TN610-05F04 Apollo Place Data Centre - Additional 20250513 RtS (r2)

Apollo Place Data Centre, 1 Apollo Place & Sirius Road, Lane Cove West - Noise & Vibration Impact Assessment (Additional response to submissions - 13 May 2025)

Table 2-1: Additional DPHI submissions (13 May 2025)

Figure 3-1: Site location, most-affected residential and commercial assessment receiver locations, land uses and NCAs

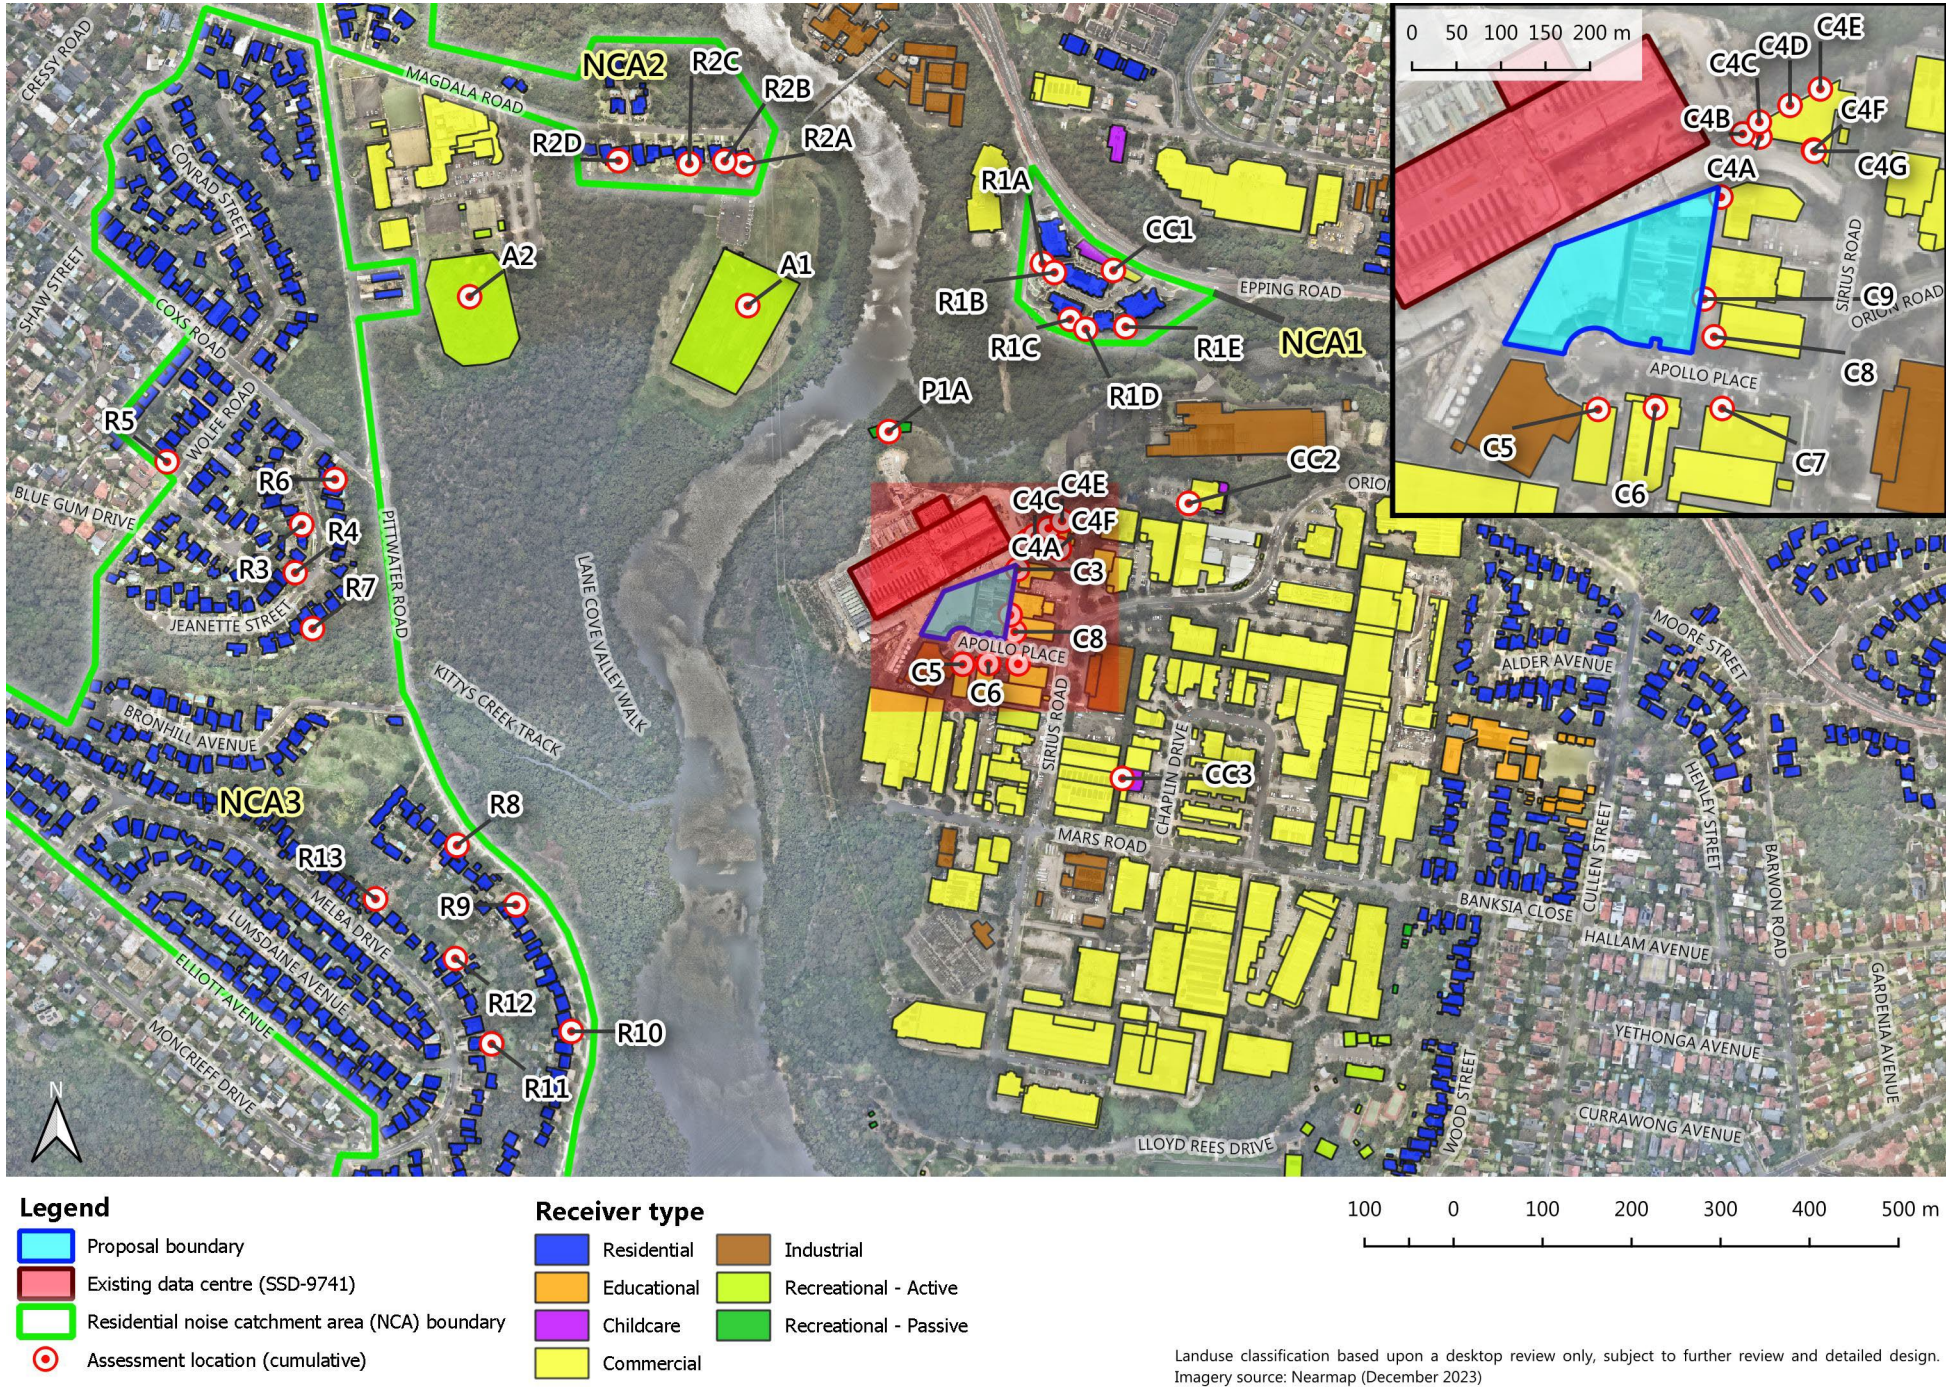
a) cumulative noise levels at all potentially most-affected residential and commercial receivers, incorporating predicted noise contributions from both the approved form of SSD-9741 and proposed Apollo Place data centre, both with and without back-up generator tests associated with the proposal	Cumulative noise levels at all potentially most-affected residential and commercial receivers are presented in Section 3.3 and Tables 3.1 and 3.2. This includes updated predictions for back-up generator maintenance testing for the Proposal combined with the existing data centre noise predictions incorporating the latest detailed design operations and acoustic strategies.

c) details of all source and pathway controls required to achieve compliance with the existing noise limits specified in Condition B14 of the SSD-9741 consent.	Cumulative noise levels at all potentially most-affected residential and commercial receivers are presented in Section 3.1 and 3.3. These cumulative predicted noise levels include the latest detailed design operations and acoustic strategies for the existing data centre as detailed in 3.1, and revised maintenance testing modelling for the Proposal as detailed in 3.1. With these updated predictions for the latest detailed design operations and acoustic strategies of the existing data centre, noise levels are predicted to achieve compliance with the existing noise limits specified in Condition B14 of the SSD-9741 consent, except at P1 during existing data centre (SSD 9741) worst-case daytime generator testing, and C3 during Proposal worst-case daytime generator testing. These residual impacts are further addressed in Section 3.4.

The assessment has been undertaken based upon a common set of 39 receiver locations, which represent the potentially most-affected residential, commercial and other sensitive receiver locations for the Proposal. These receiver locations are presented in Figure 3-1.

Predicted noise levels have been assessed to all 39 potentially most-affected residential and commercial receiver locations, and a summary of these results are presented in Table 3-1. These receiver locations are illustrated in Figure 3-1.
